INDESIT company

Model type:
WP62EX

Commercial code:
F027760

n1040251: Induction motors NO On/Off switch

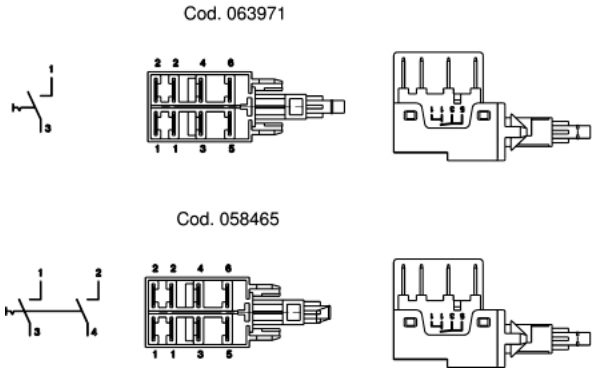
From serial number 20304.0001, the NO On/Off switch code 063971 replaces the NO + NO double On/Off switch code 058465 on all the washing machines with induction motor produced in the Teverola factory.
Both switches are regularly managed, therefore in case of repair the serial number of the unit must be taken into consideration.

FIG. 1

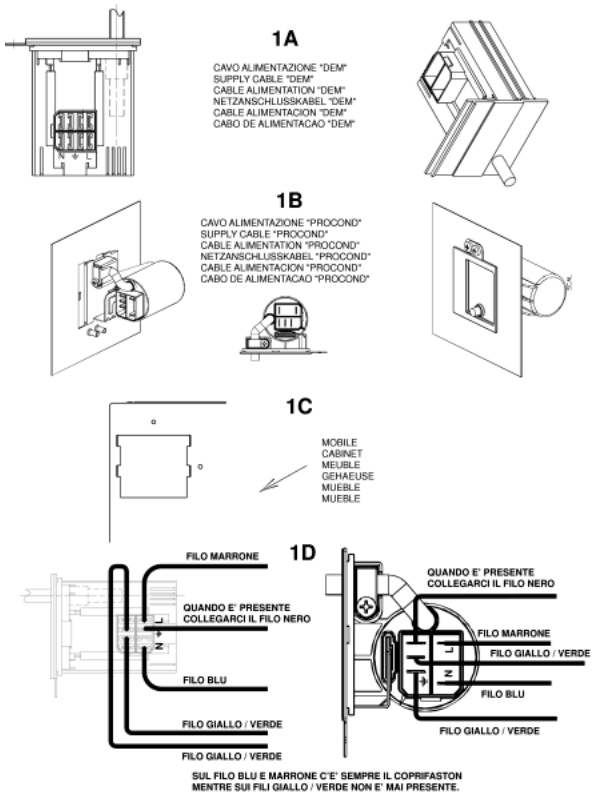
All appliances produced in the Comunanza (from serial no. 21008.0001), Teverola (from serial no. 21111.0001) and Brembate (from serial no. 21119.0001) factories have been equipped with power supply cables with integrally moulded filter (see fig.1 - 1A and 1B) and new units having a specific opening at the back for fixing the new cables (see fig. 1 - 1C).
The new units, together with the new cables, can be used in place of the premodification ones, by connecting the wiring to the cable, as shown in figure 1 - 1D.
The codes of the new units and of those replaced (ESI - table n1040276fig02), which will be managed until stocks run out, are given below.

IMPORTANT: the fixing / continuity screw is a specific self-scraping screw (code 092348) that ensures earth continuity between the filter and the unit. The same screw must be refitted in order to guarantee machine conformity.

The premodification wirings, are also managed for modified products by making the connection to the terminal block of the new cable as shown in fig. 1 - 1D.
The wiring diagrams given in the Documentation remain unchanged.

n1040279: Heater retaining element bracket and counterweight fixing

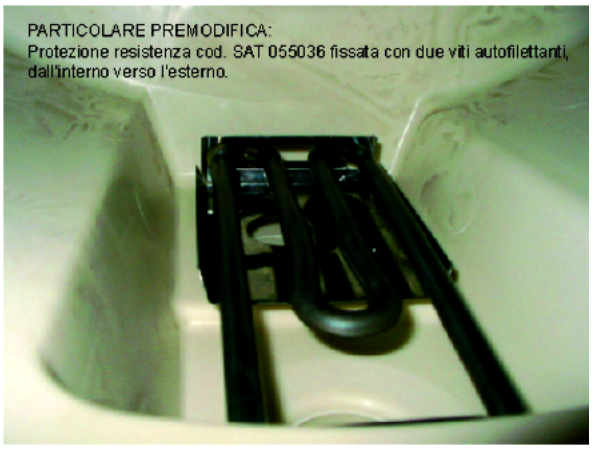
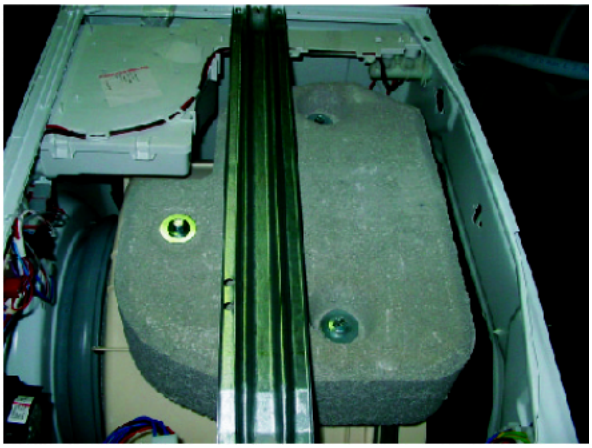
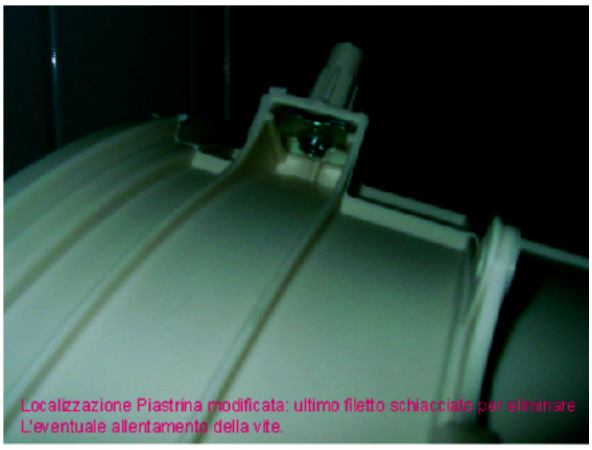
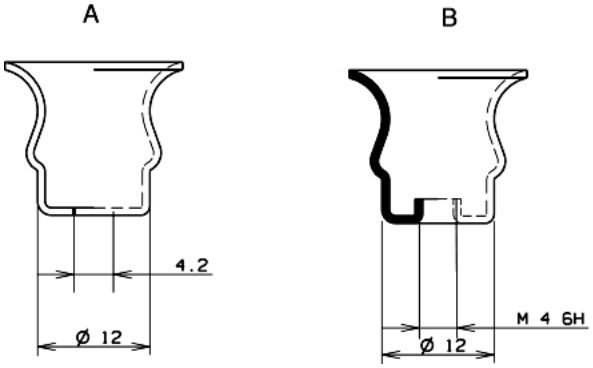
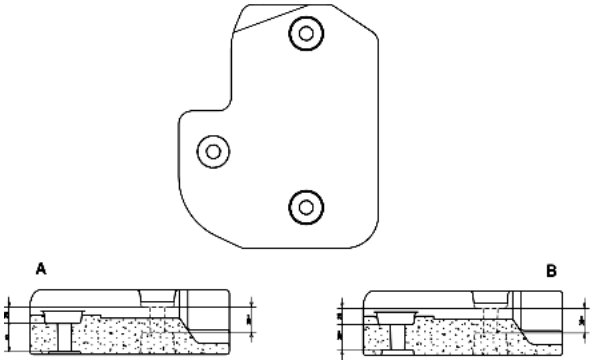
From serial no. 21015.001, a heater retaining element bracket (see fig.3) has replaced the heater retaining element protection Sat code 055036 (see fig.4) on all plastic tanks installed in washing machines produced in the Teverola factory.

The new part (fig. 1A) is fixed to the bowl with a self-tapping screw from the inside outwards and differs from the one used in the Comunanza factory (fig. 1B) in the fixing hole which is not threaded.
In order to reduce the number of parts used, only kit 058523 is managed and which, if used on the Teverola washing machines, must be fixed with a self-tapping screw, instead of metric, after widening the tapped hole with a suitable drill bit.
When inserting the heater retaining element, particular care must be taken so that it is fitted correctly (Fig. 3).
The plastic tanks to be arranged for the guide have the same Sat code as those with the protection.

>From serial no. 21121.0001, the counterweight Fig. 2B with outlet increased by 5 mm in the centre has replaced the previous counterweight Fig. 2A.
The new counterweight (fig. 5) is fixed using three M8 X 63 mm screws with washer code 092016 (see fig. 8) and three plates with the last thread flattened (fig. 6) to prevent accidental loosening of the screw.
All the plates code 055038 in stock in the Centralised Warehouse have been replaced and can also be used on premodification appliances.
The modified counterweight has the same Sat code as the premodification item (066615) that will be managed until stocks run out.
The new counterweight must be assembled using the new screws and plates (see fig. 7).
Both counterweights can be employed necessarily using the following fixing parts which are specific for each type of counterweight:

Fixing parts for premodification counterweight (see fig. 9):
3 pieces code 055019 - Screw M8 X60 mm;
3 pieces code 055018 - Conical washer;
3 pieces code 034336 - Flat washer;

Fixing items for modified counterweight:
3 pieces code 092016 - Screw M8 X 63 mm with washer;
3 pieces code 055038 - Plate with last thread flattened;

FIG. n1040305fig01

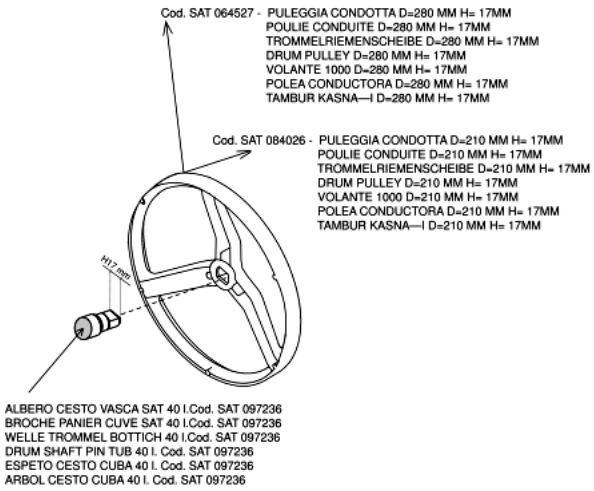
·Eeproms - The new software for the 40 litre EVO washing machines can also be used on premodification appliances; it is managed with the same Sat codes as the previous software, which is being immediately replaced as the new models enter into production.
·Pulleys - The use of a single 40 litre bowl assembly in Assistance involves management of the pulleys used in production (097268 and 097267) and also those required for creating the various combinations (see fig. n1040305fig.01):

NB: From serial no. 31103.0001, all EVO appliances are equipped with a 40 litre bowl with H=15 mm drum cross shaft which will be managed with the same SAT code (097236) as the 40 litre bowl with H=17 mm shaft until stocks last.
To create the various combinations, the following pulleys are required:

Code 097268 - Pulley D=280mm H=15 mm;
Code 097267 - Pulley D=210mm H=15mm.
Exceptions to this are models W93UK (23330) and W103UK (23334) which are equipped with a 46 litre bowl; therefore if the bowl needs replacing code 096198 with 20 mm pulley cross shaft must be used.
In production, pulley code 064527 (diameter D= 280 mm and central hole H= 17mm) is used; therefore, when replacing the bowl, code 097269 (diameter D= 280 mm and central hole H= 20mm) must be used.

Code 064527 - Pulley D=280mm H=17 mm;
Code 084026 - Pulley D=210mm H=17mm.
